## DESIGN RESPONSE CONFERENCE

**8505 132nd Avenue NE  
Kirkland, WA**

November 18, 2019

^ CDC #1 OPTION A - Bird's Eye View

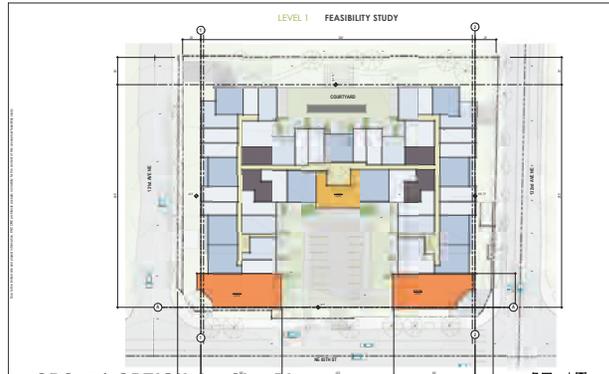
- Main courtyard opens to the south, with smaller court to the north
- Main courtyard is primarily parking, instead of amenity space
- Parking lot requires entry from NE 85th St. (not permitted by traffic engineer).
- More undesirable inside-corner units.
- Commercial spaces disconnected, poor pedestrian pathway across site.

^ CDC #1 OPTION B - Bird's Eye View

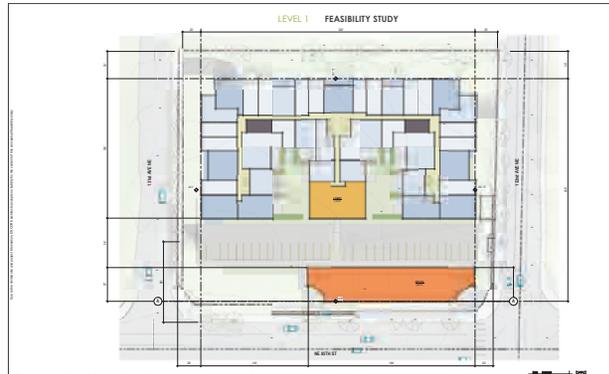
- Two small courtyards opening to the south.
- Courtyards are too small for large gathering space, create many inside corner units
- Parking lot extends across almost entire site, with very little screening.
- Single, separate commercial building appears small and disconnected in front of larger residential building.
- Suburban, rather than urban pedestrian experience along NE 85th St.
- Small commercial building makes poor gateway element @ corner of NE 85th St, & 132nd Ave. NE

^ Current Design - Roof Forms

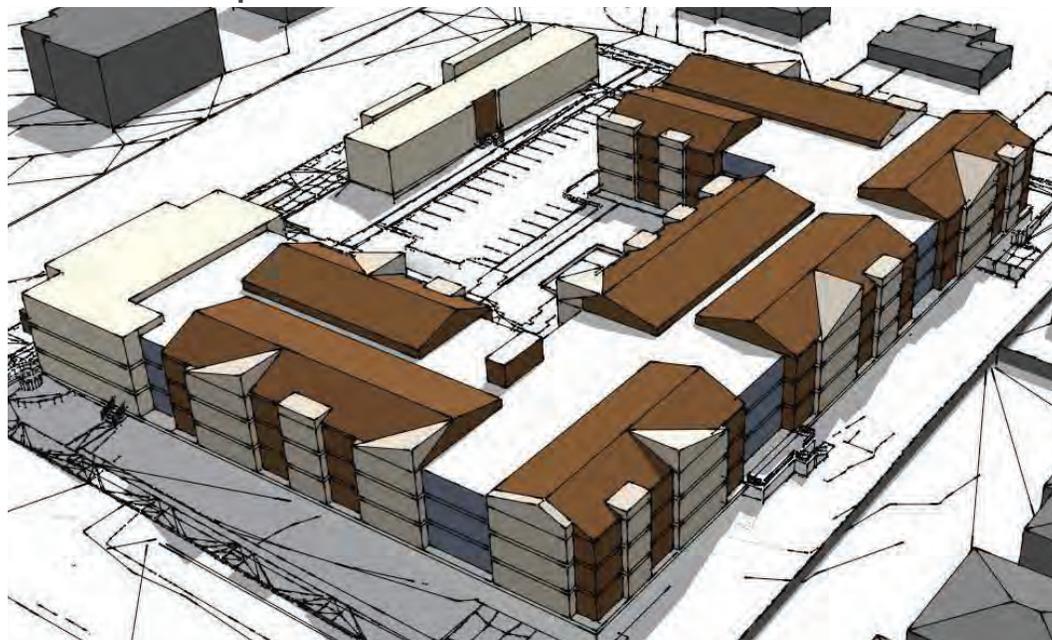
- Increase the amount of vertical and horizontal modulation, specifically along the longer east and north facades. Varying roof heights and forms would help to create the look of smaller buildings. Increase depth and width of horizontal modulations. See Guidelines 17 and 18.

- Main flat roof with parapets; where height of parapet changes for distinct forms.
- Unequal gable roof masses to create smaller scale and residential character.
- Gable roof peeled away to create accent roof dormers.
- Small parapet roof at narrow accent bays.
